THM 4T65-E UPDATE HANDBOOK

INTRODUCTION THM 4T65-E UPDATE HANDBOOK

Technical Service Information

Figure 21

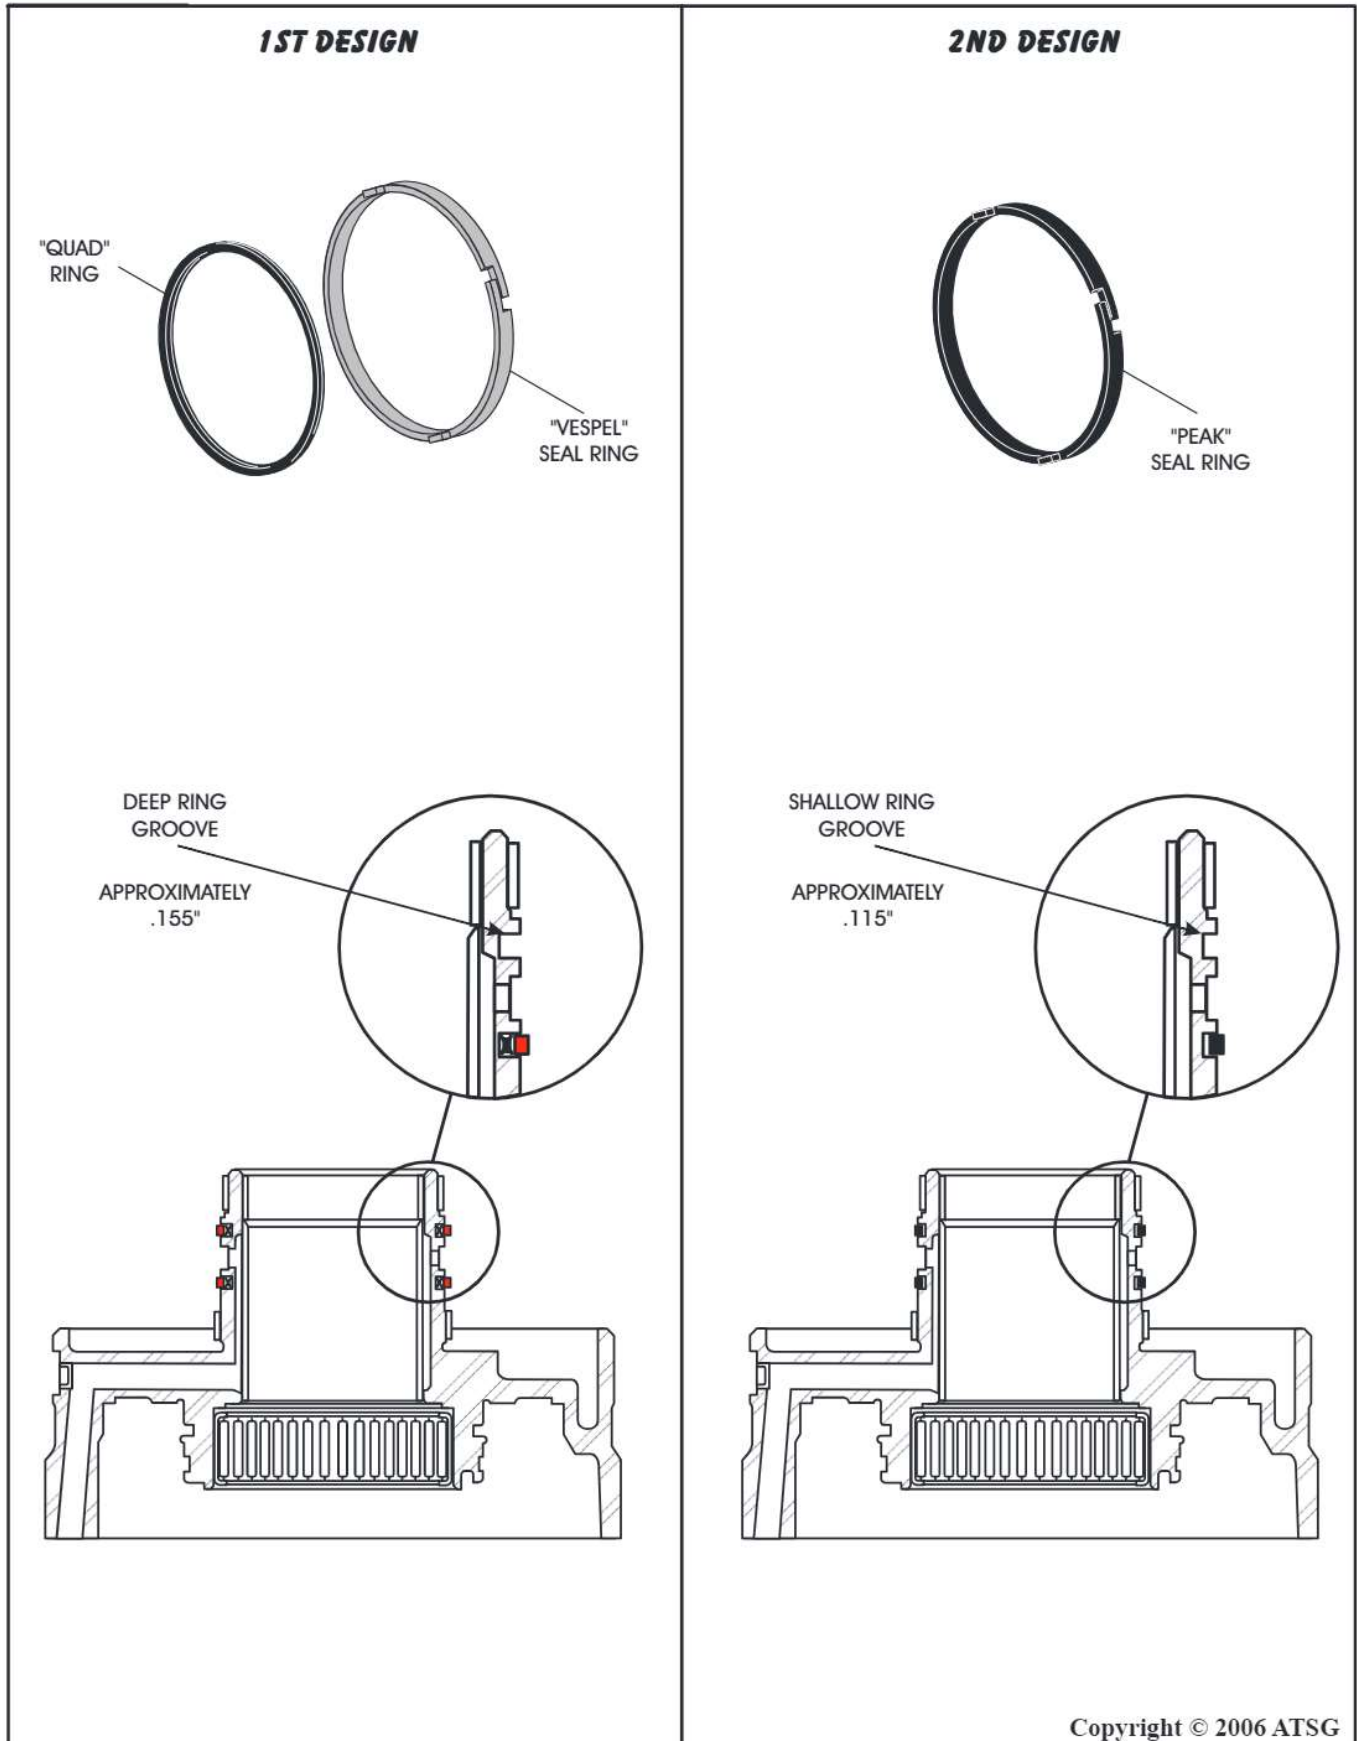
CHANGE: During the 1998 model year, and implemented as a running change, GM Powertrain eliminated the rubber "Quad-Ring" that was used as an expander for the Vespel sealing rings on the driven sprocket support, as shown in Figure 21. There was also a change of material for the sealing rings that occurred at the same time. "Vespel" material was eliminated, and "Peak" material was implemented, as shown in Figure 21.

- (1) RUBBER QUAD-RING - The rubber quad-ring, that was used in the seal groove under the "Vespel" seal ring as an expander, was eliminated (See Figure 21).
- (2) VESPEL SEALING RINGS - The Vespel material sealing rings were replaced with a "Peak" material at the same time (See Figure 21). The "Vespel" seal rings are Brown in color, and the "Peak" seal rings are Black in color.
- (3) DRIVEN SPROCKET SUPPORT - The seal ring grooves were not machined as deep on the second design sprocket support, to accommodate the new design seal rings without the rubber quad rings. The groove depth on 1st design is approximately .155", and groove depth on the 2nd design is approximately .115". Refer to Figure 21.

The first design driven sprocket support *must* be used with the rubber quad-rings.

Figure 22

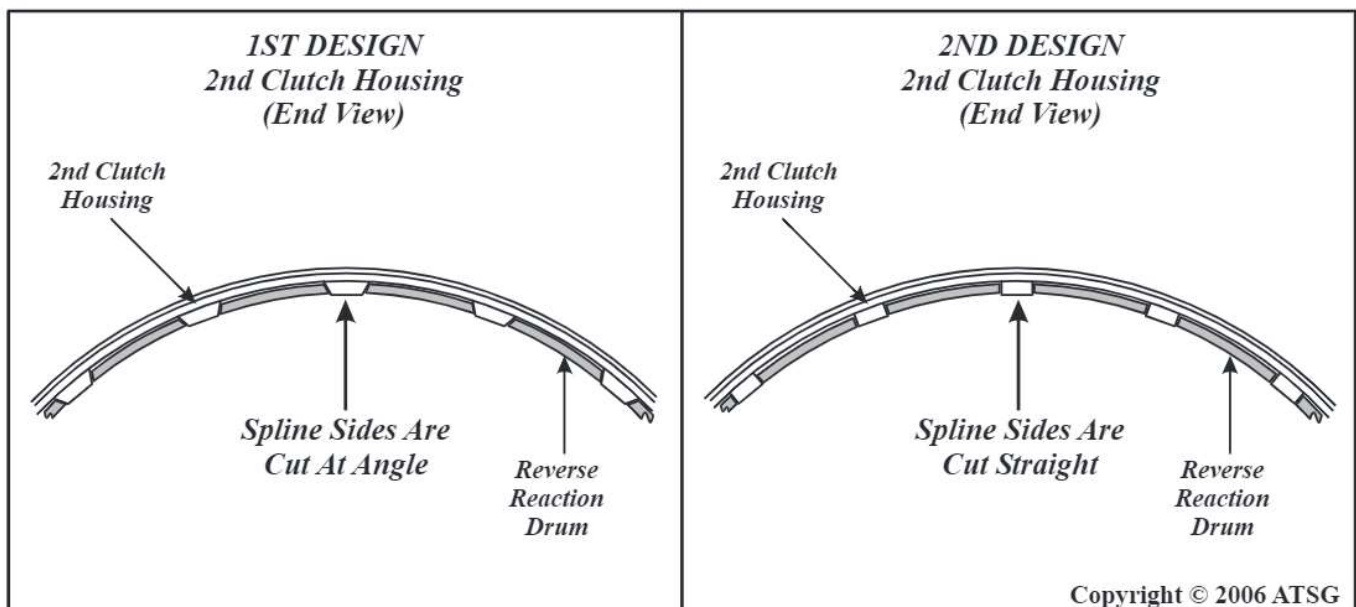
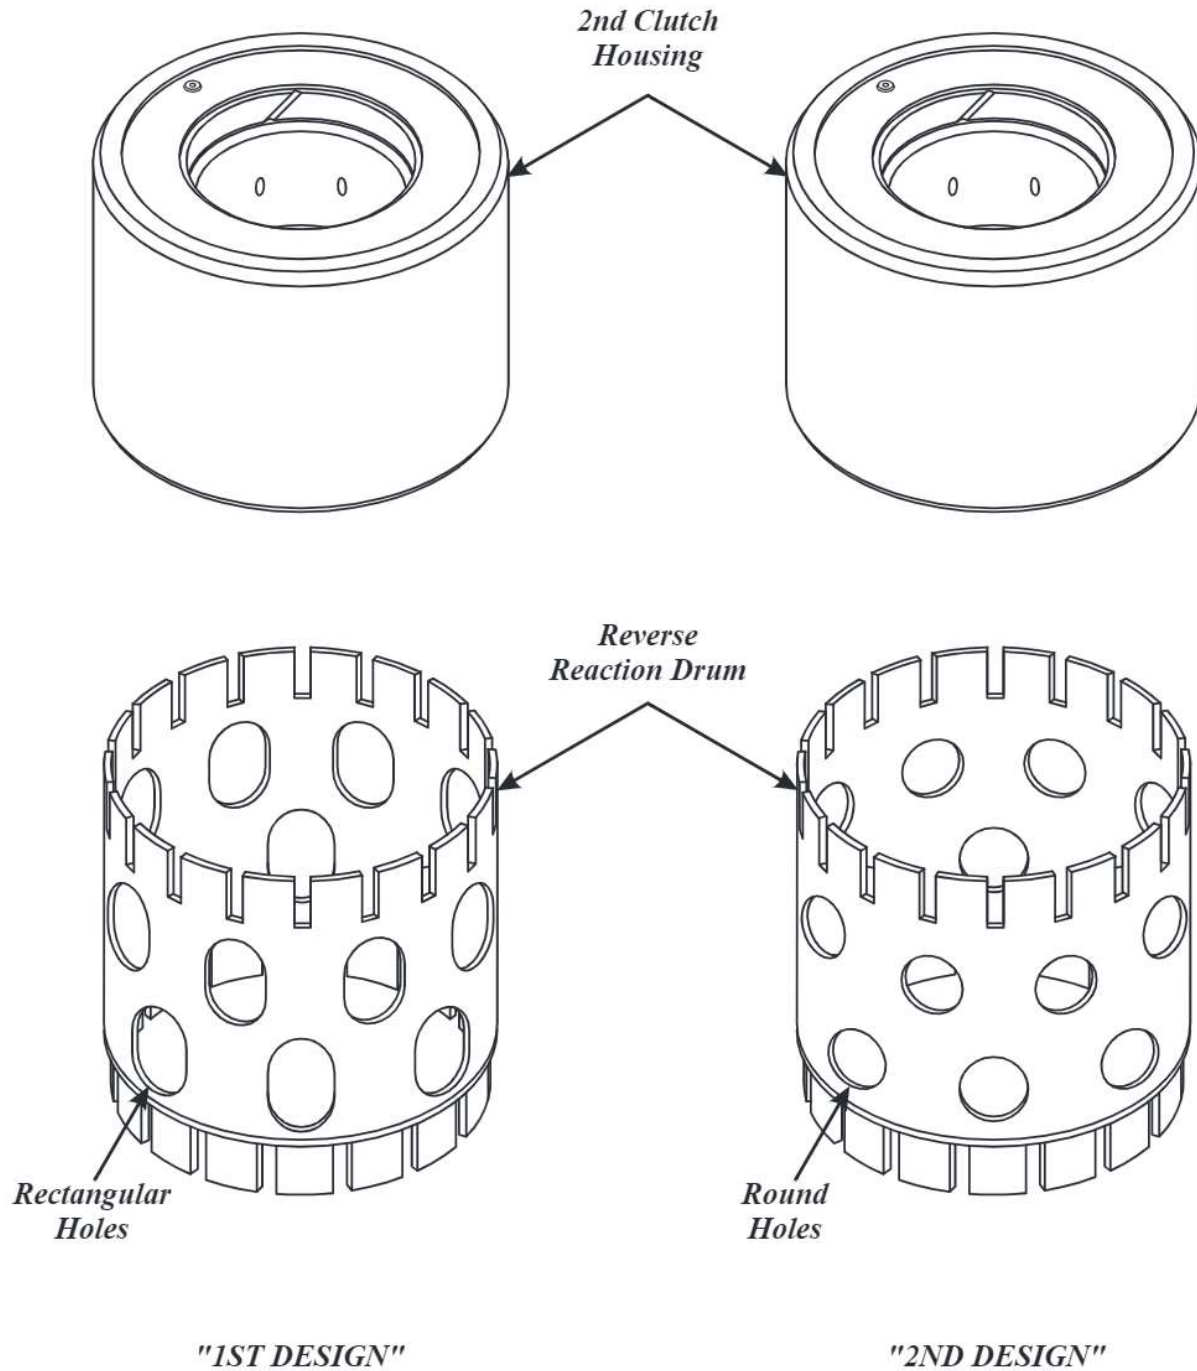
- (1) **REVERSE REACTION DRUM** - Received some very slight dimensional changes on the splined end that enters the 2nd clutch housing. The sides of the slots that spline into the 2nd clutch housing were machined straight, as shown in Figure 22, and can be easily identified with the round holes stamped in the drum, as shown in Figure 23.
- (2) **2ND CLUTCH HOUSING** - Received some very slight dimensional changes on the internal splines, where the reverse reaction drum mates with the 2nd clutch housing. The sides of the splines in the 2nd clutch housing were machined straight, to accommodate the revised slots in the reverse reaction drum, as shown in Figure 22. There are no other means of identification on the 2nd clutch housing.

There is a Service Package that includes both parts, and is available from GM, under OEM part number 24213402

Figure 24

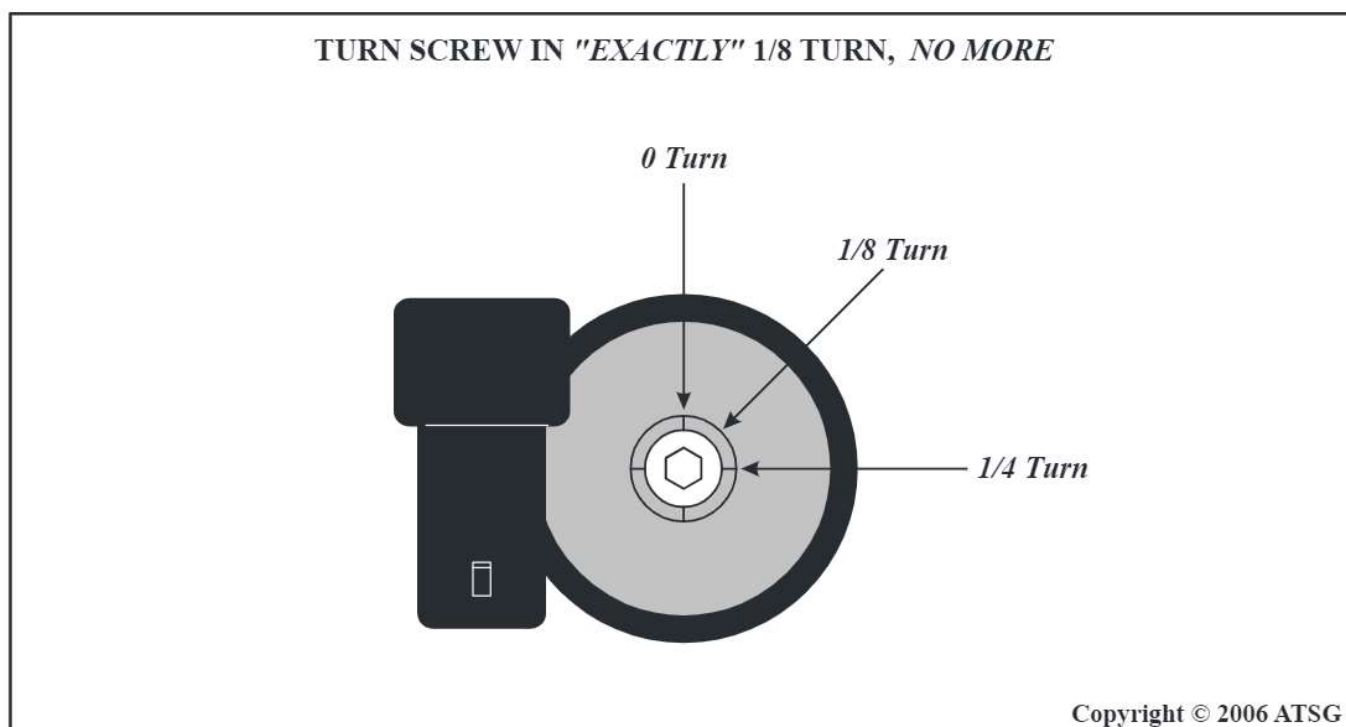
CORRECTION: Replace the Pressure Control Solenoid with the *updated* PCS, available from OEM under part number 10478146. Before installing the new PCS, turn the adjusting screw on the end of the solenoid in *exactly 1/8 turn*, as shown in Figure 24. Inspect and replace as necessary, the boost valve and sleeve assembly located in the valve body, in the location shown in Figure 25. This valve train is available from Sonnax®, under part number 84754-30K, and is not yet available from OEM except in a complete valve body assembly.

Pressure Control Solenoid (New Design From OEM) 10478146
Boost Valve and Sleeve Kit (Sonnax® Part No.) 84754-30K

Figure 26

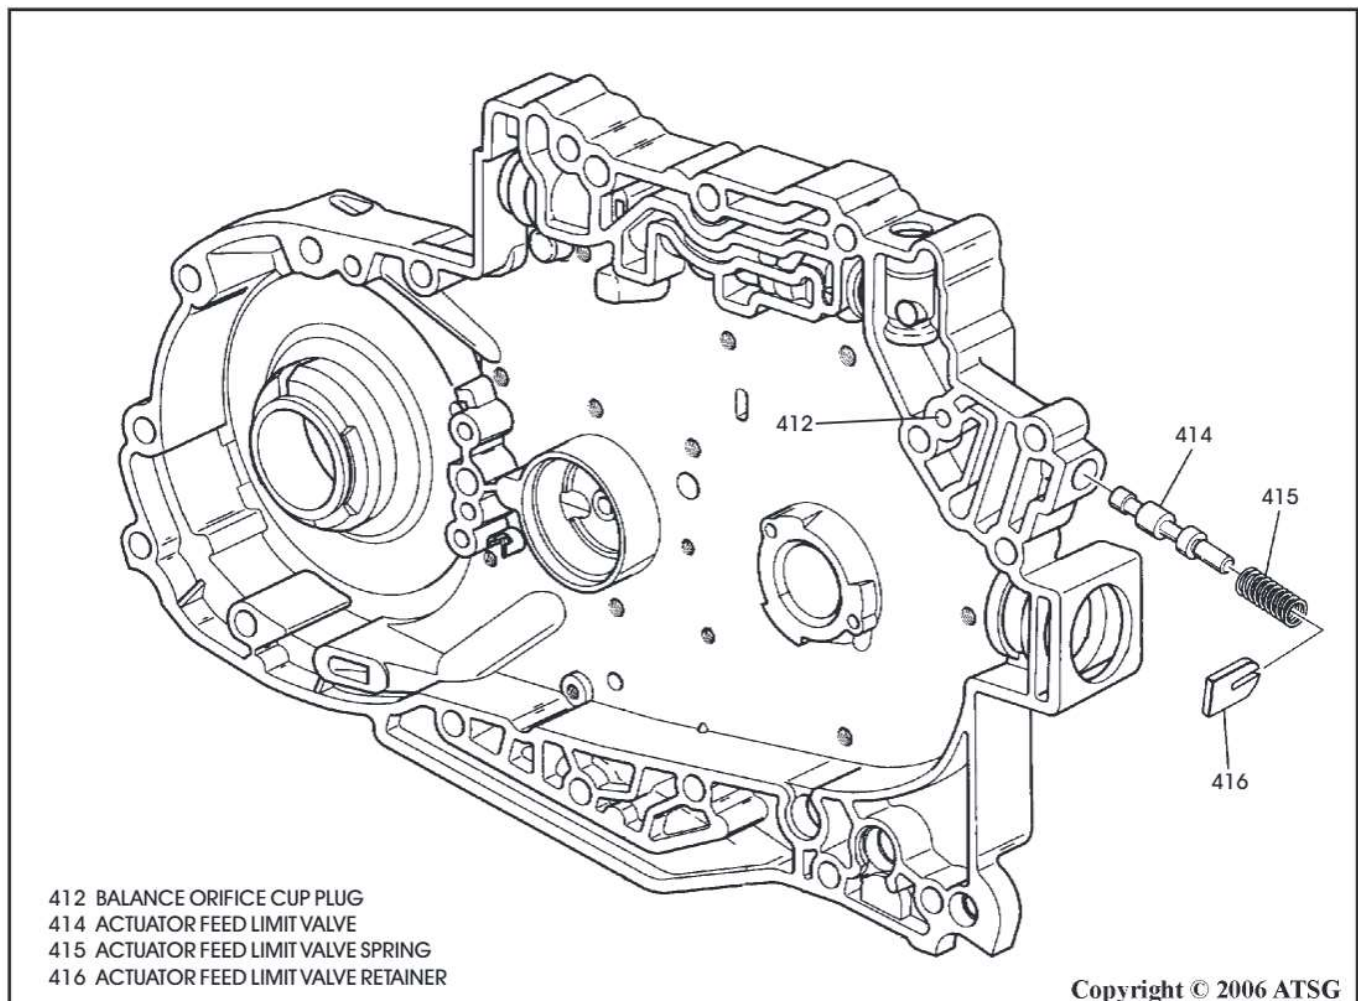
CAUSE: One cause may be a stuck Actuator Feed Limit Valve, located in the channel plate, as seen in Figure 26. With this valve stuck, solenoid feed oil to shift solenoid 1-2/3-4 is either blocked or has insufficient flow rendering the solenoid inoperable as if the solenoid failed in the stuck off position mechanically. Shift solenoid 2-3 is not fed with Actuator Feed oil allowing it to continue to function as designed and thereby causing only second and third gears to be available, irregardless of the proper shift commands being provided by the computer. Also, inspect the orifice cup plug (412), as shown in Figure 26, for any debris that may be clogging the orifice.

CORRECTION: Free the Actuator Feed Limit valve.

Figure 27

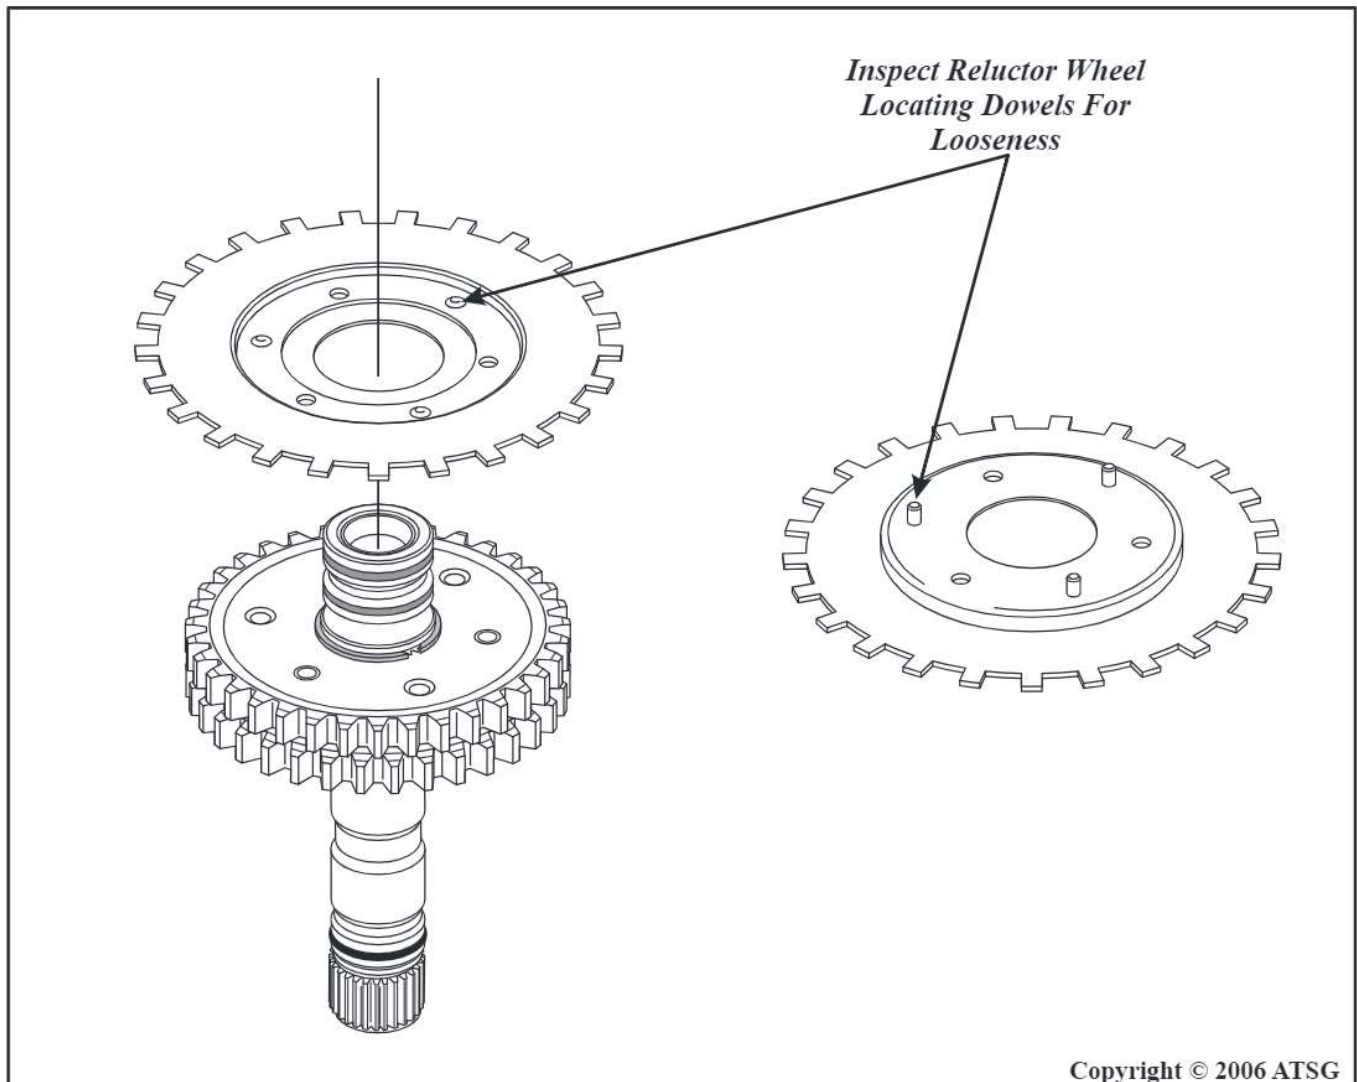
CAUSE: The cause may be, the locating dowels (rivets) being loose in the input speed sensor reluctor wheel. Refer to Figure 27.

Input Speed Sensor Reluctor Wheel 24212217

Figure 39

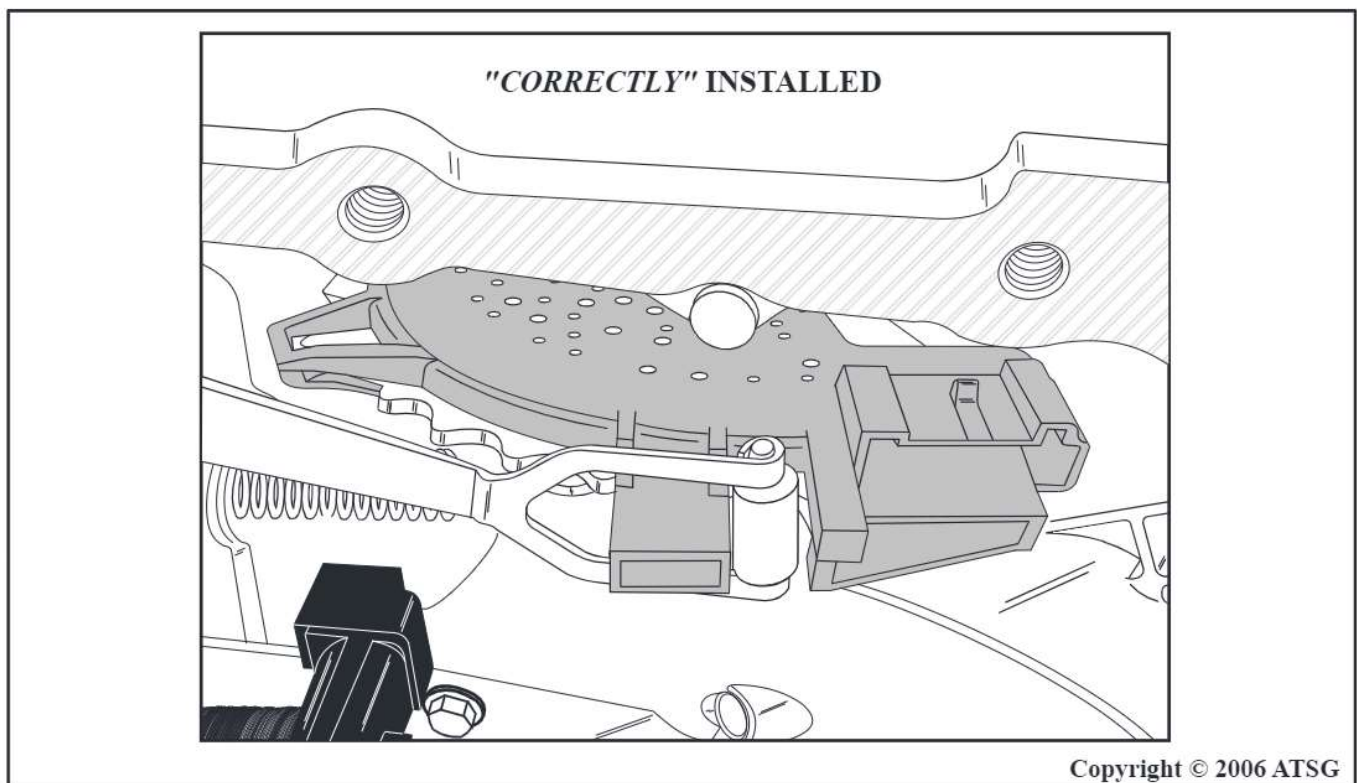
CAUSE: When the detent spring was installed during the overhaul, it ***was not*** indexed in its proper location at the IMS which can be seen in Figure 38. When this is done the IMS can move across the detent lever ¼" in either direction. Therefore movement of the shift lever is not synchronized with the IMS causing the above complaints.

CORRECTION: Install the detent spring at the IMS as shown in Figure 39. ***It is the detent spring roller that properly indexes the IMS.*** When the IMS and detent spring are indexed correctly, there will be no movement of the IMS across the detent lever.
